M.O. Neasloney WMA- ADA Evaluation

Accessibility Evaluation

Inspection Date: 12/08/2021

Report Date: 01/21/2024

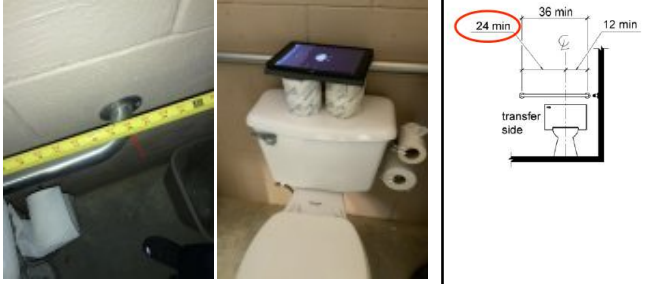
Finding Number	Area Description	Finding	As Built	Recommendation	Citation	Photos	Figure
1	Exterior of Property (Public): HQ Parking Lot (1 Space) Unlabeled	The parking lot has been found to be in substantial compliance with accessibility codes, standards, and regulations.	Parking lot marked as compliant. Need photo verification.	N/A	2012 TAS Section: Advisory 2010 ADAS Section: Advisory 2015 ABAAS Section: Advisory		
2	Exterior of Property (Public): HQ Parking Lot (1 Space) Unlabeled - Van Accessible Stall	The van stall is missing a sign identifying it as a van accessible stall. Parking space identification signs shall include the International Symbol of Accessibility. Signs identifying van parking spaces shall contain the designation "van accessible."	Need photo verification	https://www.access-board.gov/aba/#aba-502_6	2012 TAS Section: 502.6 2010 ADAS Section: 502.6 2015 ABAAS Section: 502.6

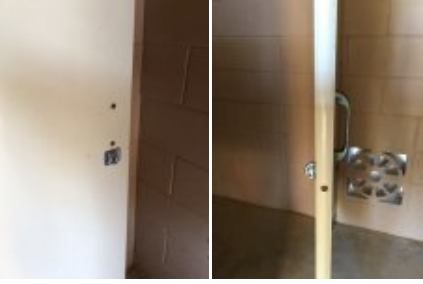
Finding Number	Area Description	Finding	As Built	Recommendation	Citation	Photos	Figure
4	Structures on Property (Public) : HQ Building (Exterior) - Pathway to HQ Building	The concrete expansion joint is spaced greater than 1/2 inch. Openings in floor or ground surfaces shall not allow passage of a sphere more than 1/2 inch diameter. Elongated openings shall be placed so that the long dimension is perpendicular to the dominant direction of travel.	Pathway has a few locations where gaps exceed 1/2" tolerance. See additional photos for location.	https://www.access-board.gov/aba/#aba-302_3	2012 TAS Section: 302.3 2010 ADAS Section: 302.3 2015 ABAAS Section: 302.3		
5	Structures on Property (Public) : Public Restrooms - Restroom (Men's)	The water closet compartment is missing a loop handle on the one side of the door. Water closet compartments must be equipped with a door that has a loop or U-shaped handle on both sides of the door near the latch. The latch must be flip-over style, sliding or other hardware not requiring the user to grasp or twist.	N/A	https://www.access-board.gov/aba/#aba-604_8_1_2	2012 TAS Section: 604.8.1.2 2010 ADAS Section: 604.8.1.2 2015 ABAAS Section: 604.8.1.2
